Addendum No. 1

RE: Contract # C204175 WBS # 45901.3.1 F. A. # NHPIM-0040 (073) Forsyth County (I-5952) I-40 From SR-1101 (Harper Road) In Clemmons To East Of US-421/I-40 Business In Winston-Salem

November 20, 2018 Letting

-L- MEDIAN SHOULDER DRAIN DETAIL

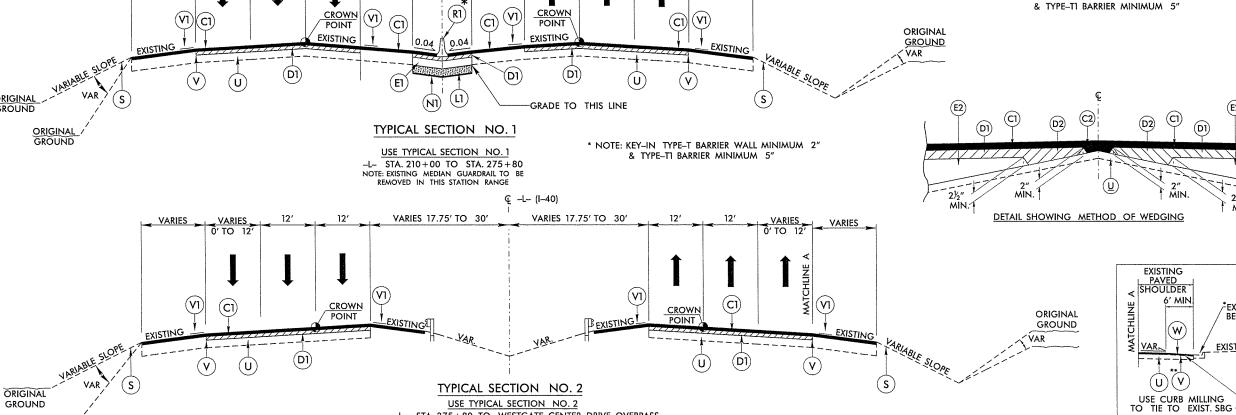
Sheet No.	Revisions		
2A-1 Revised the typical section to show the Double Faced Concrete			
Median Barrier keyed into the asphalt layers			
New 2C-3 and 2C-4 New sheets to include details about the median hazard pro			
	existing overhead sign location and existing bridge pier location

* NOTE: KEY-IN TYPE-T BARRIER WALL MINIMUM 2" & TYPE-TI BARRIER MINIMUM 5"
